**AGENDA**  
**HISTORIC PRESERVATION/  
DESIGN REVIEW COMMISSION**

# Administrative Staff Report

**Design Review  
1500 Clark Street  
August 26, 2024**

**RE: Design Review – 1532 Clark Street**

**Design Drawing for Back Porch at 1500 Clark Street:** The following two pages have design drawings for rebuilding of the porch at 1500 Clark Street. The drawings are color coded with some written explanation. Below is a summary of the color coding.

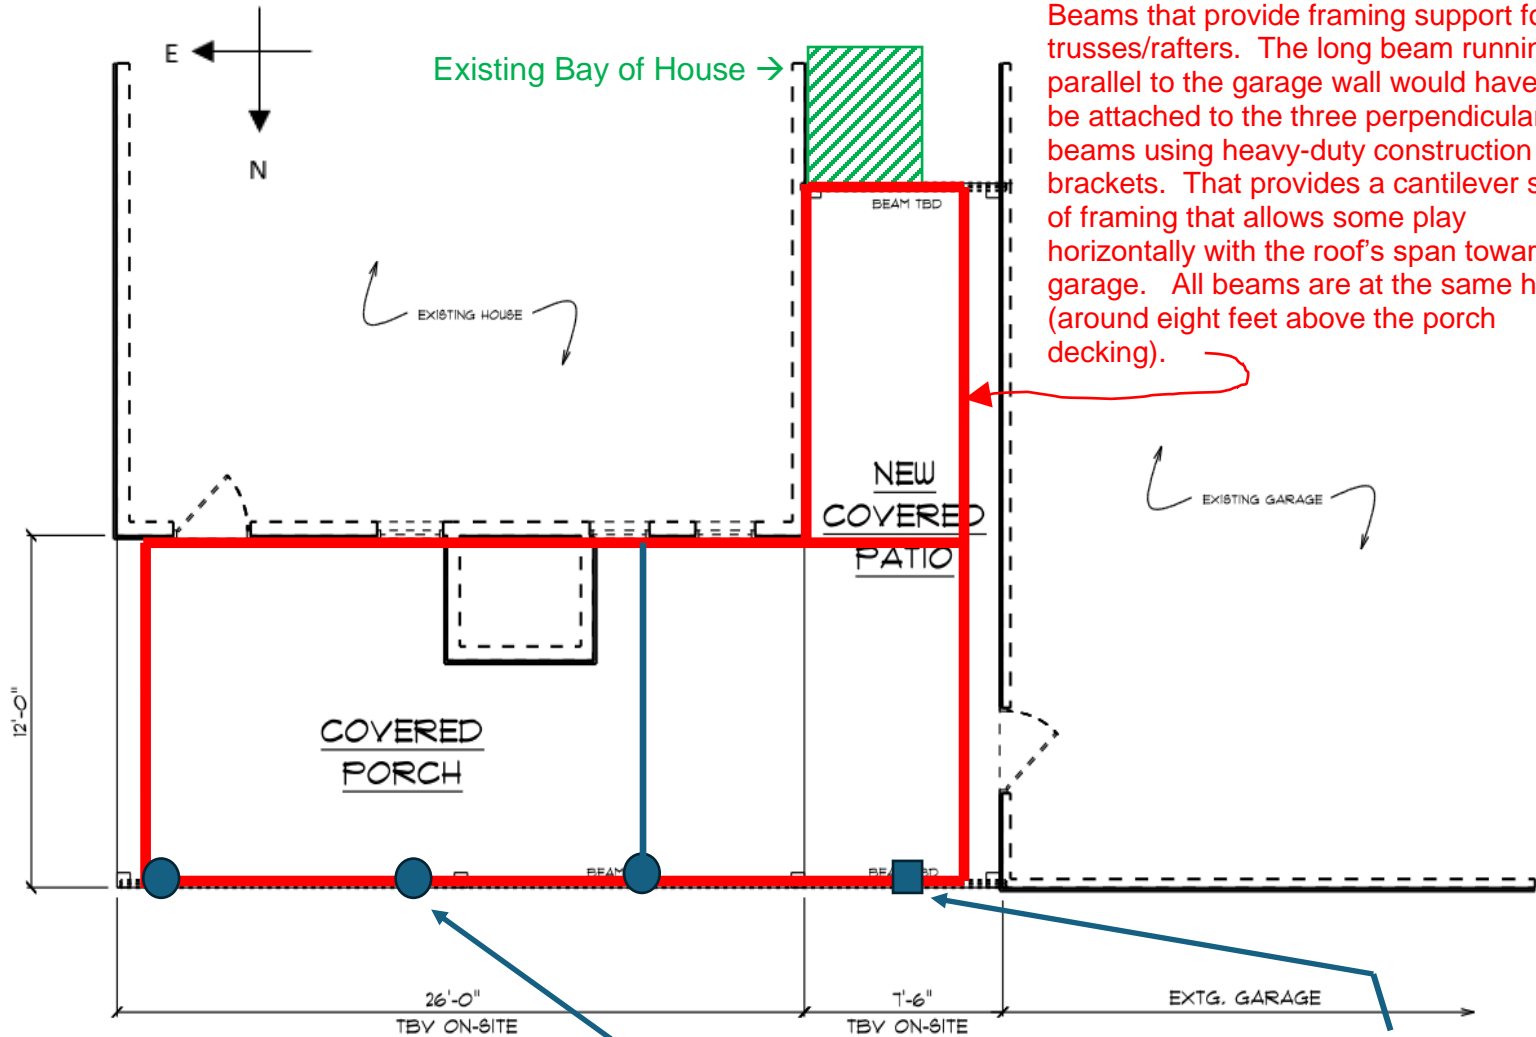
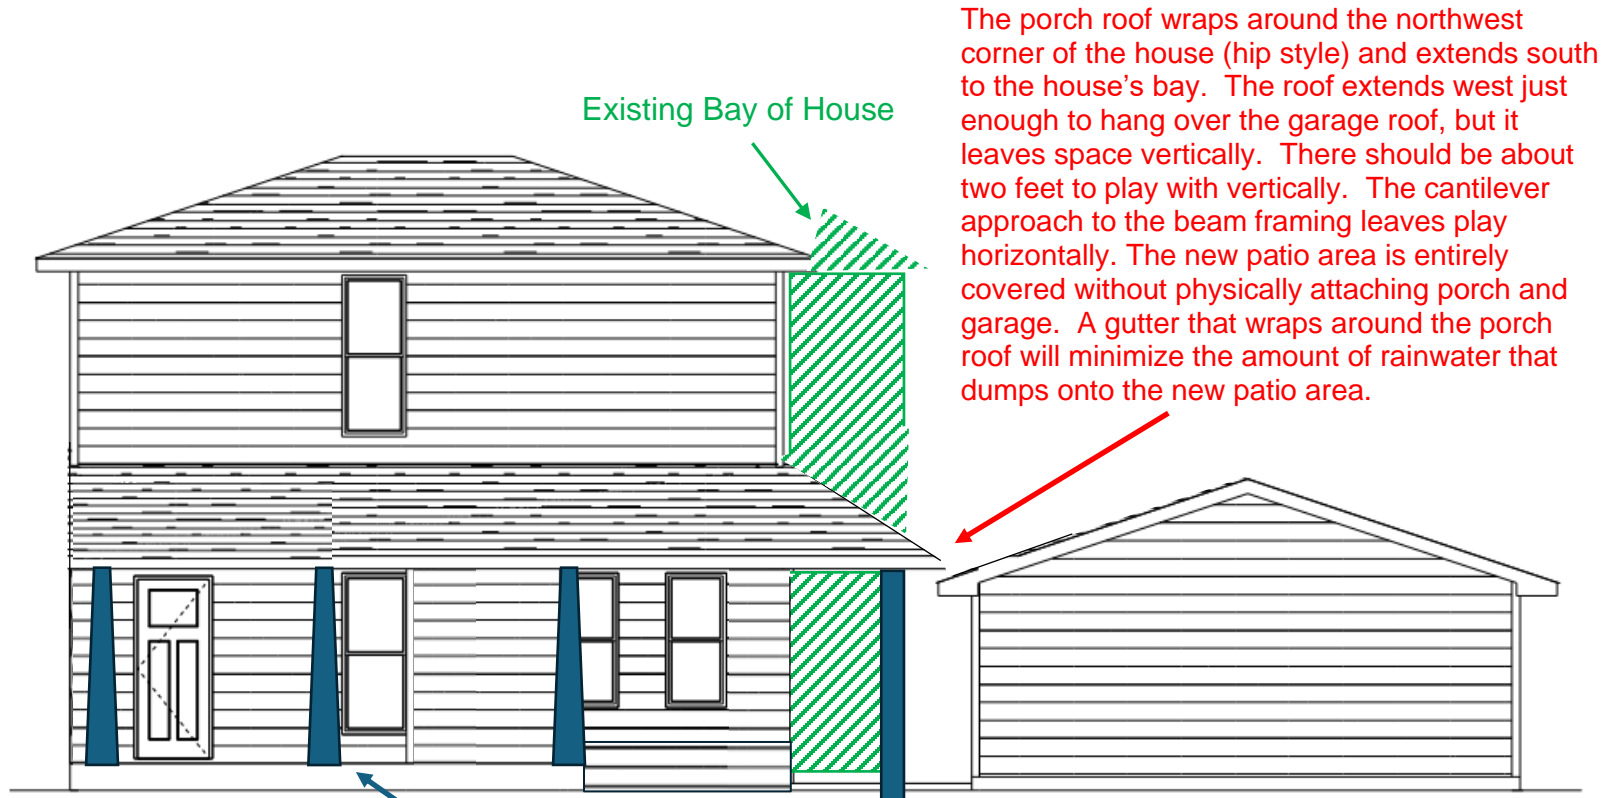
**Analysis:** The applicant is proposing to rebuild the back porch that extends out eight more feet to the north. The new porch overhang will be nearly identical to that of the existing overhang, while new posts will be affixed that matches in appearance to the posts on the front porch.

**Findings:** While the Commission's Design Guidelines place architectural requirements for porch, deck and patio projects, said architectural requirements relate primarily to the front elevation of a house. The back porch on the subject property, like other houses within the Clark Street Historic District, has a significantly diminished architectural significance when compared to the corresponding front porch. This fact is not too dissimilar to housing construction both in the past and the present – such as variations in siding type being used for new construction for the front elevation of a building and for the other 3+ sides. As such, the applicant has been working with myself to ensure that the new porch design would be built in a way that compliments, but not mimics the design of the front porch. As shown within the applicant's project proposal, I believe that it has been achieved.

**Findings:** Part of the reason why the deck and steps have experienced water damage is due to the roof overhang 1.) not matching the depth of the porch that it is supporting and 2.) not being 100% weathertight. The project proposal will assist in improving the longevity of the new building material, thus not negatively impacting the architectural significance of the building as a whole.

**Finding:** Historic photographs showing the back porch does not exist. As such, the applicant has designed the proposed back porch in a way that compliments the design of the front porch and is consistent with the overall building style for the period of architectural significance.

### Drawing to show what actual unit will look like not drawn to scale

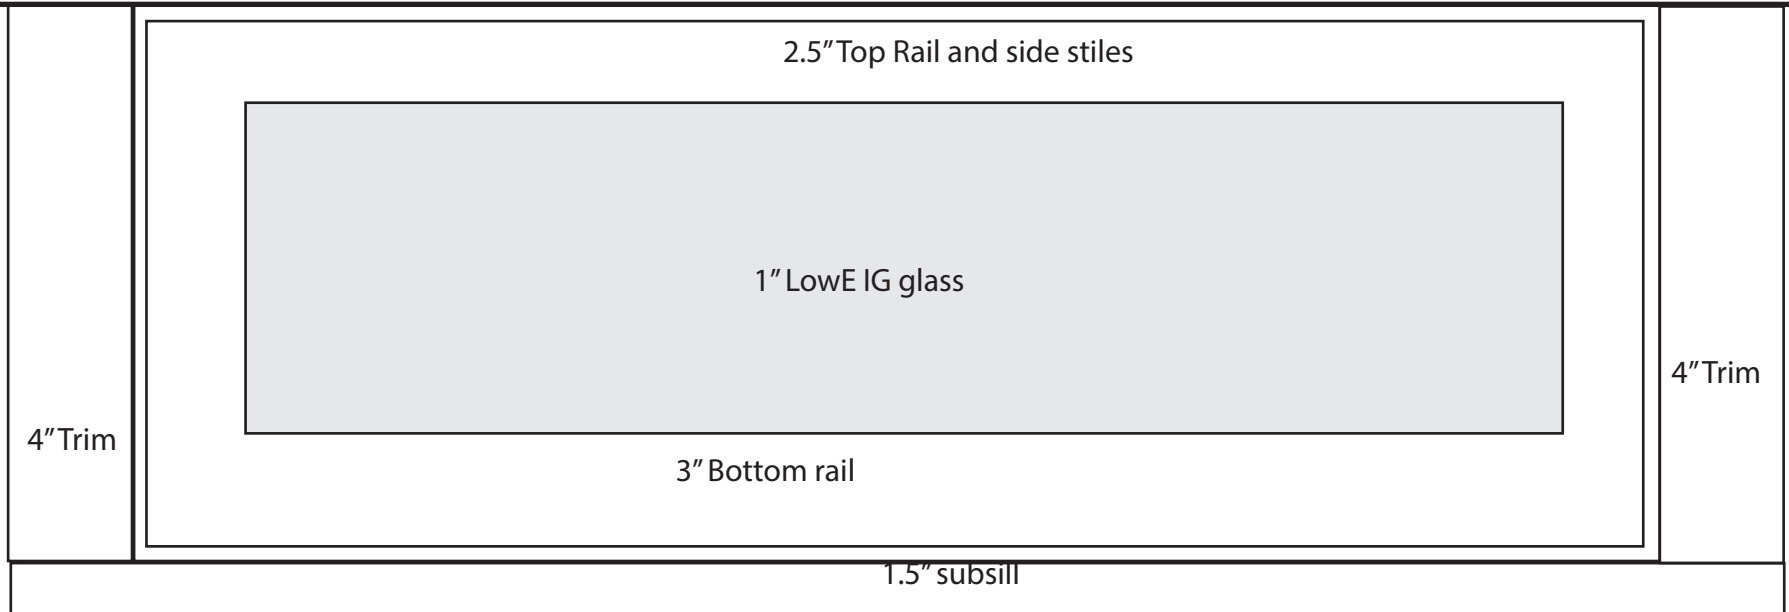
The applicant is requesting to remove the wood board and utilize the existing opening for a new window. The size of the window frame will be 26'' in height and 60'' in length, with 4'' wood trim that will match the existing siding in texture, color and dimensions. While most of the windows on the house are double-hung, the proposed window will be single-hung and be consistent with other single-hung windows (e.g., the single-hung window located on the first-floor, front elevation of the house).

Like the previous agenda item, a literal application of the Commission's Design Guidelines would not permit the filling in of a window opening. As such, this request to correct a prior 'wrong' by reintroducing a former window opening is viewed favorably by me. I would recommend approval of this project, subject to the following conditions:

1. Caulking and weather stripping shall be provided to ensure the unit is weather tight and to improve thermal efficiency.
2. The proposed paint color for the wood trim shall be sent to the Designated Agent for review and approval.
3. A building permit shall be obtained prior to the start of construction.
4. The Designated Agent shall have the ability to approve minor amendments to the project plan.
